BLOOR HOMES

DRG NO.: NSS.M3B5P_05

NAME: SUTHERLAND

DRAWING: CLA BRICK ELEVATIONS

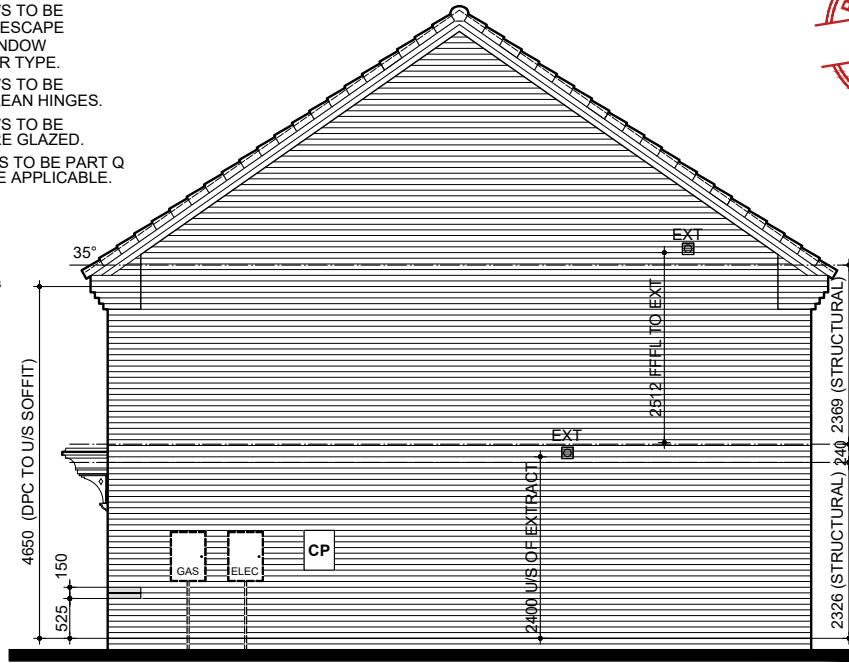
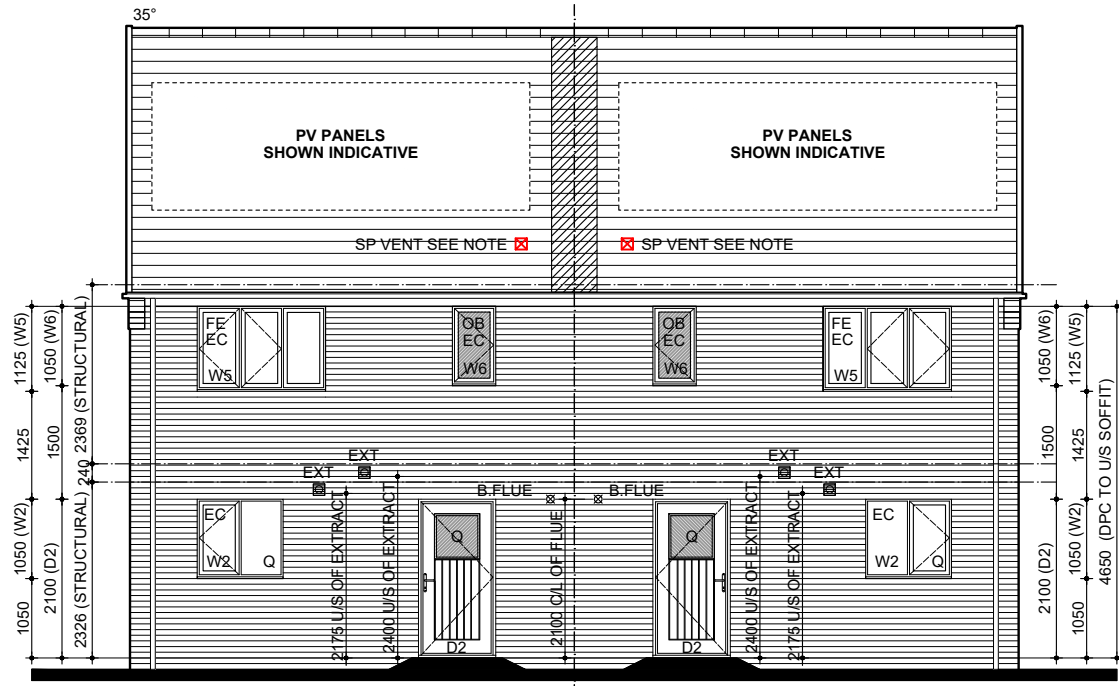
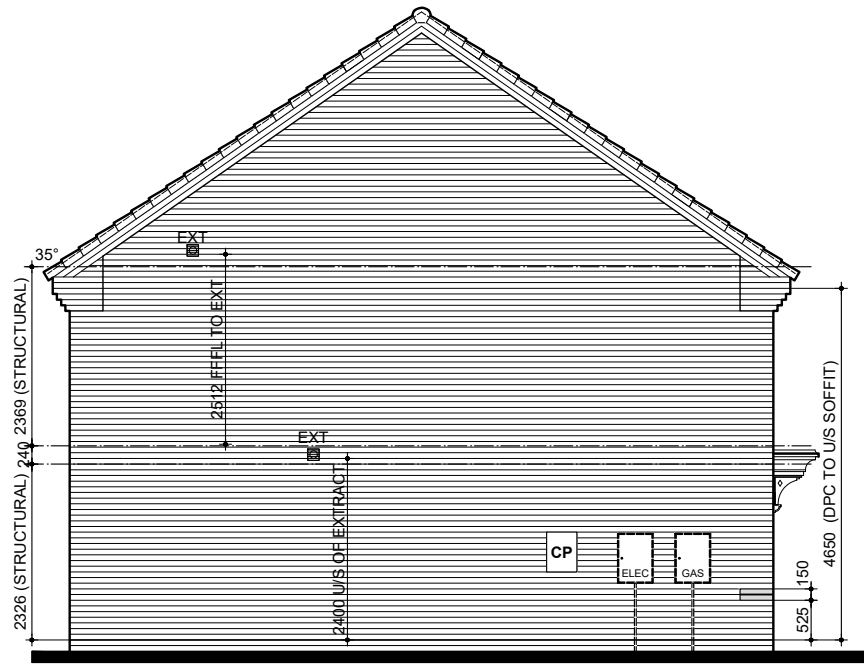
BATHROOM EXTRACT FANS
REVISED TO CEILING MOUNTED
TO GABLE END IN LINE WITH
FEEDBACK.
